**CENTER FOR DRUG EVALUATION AND  
RESEARCH**

**202450Orig1s000**

**ADMINISTRATIVE and CORRESPONDENCE**  
**DOCUMENTS**

Trade Name Tudorza Pressair

Figures 1 and 2 show the difference between the two rings.

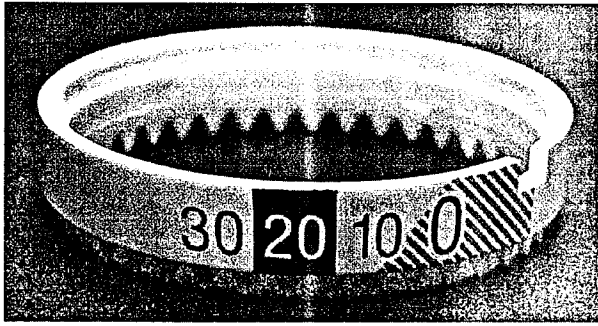
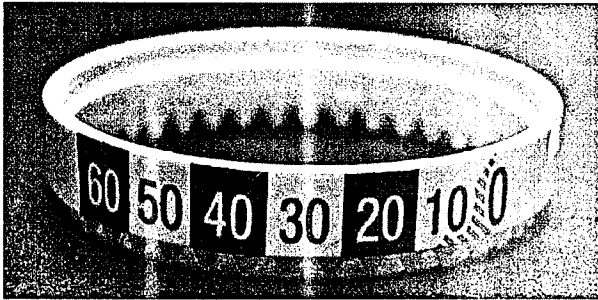
The 30 dose and 60 dose devices are manufactured using the final formulation in Forest Laboratories Ireland, the manufacturing site for commercial product using the molds and assembly of devices intended for final commercial product. The only difference between the two devices is the dose counter/indicator ring.
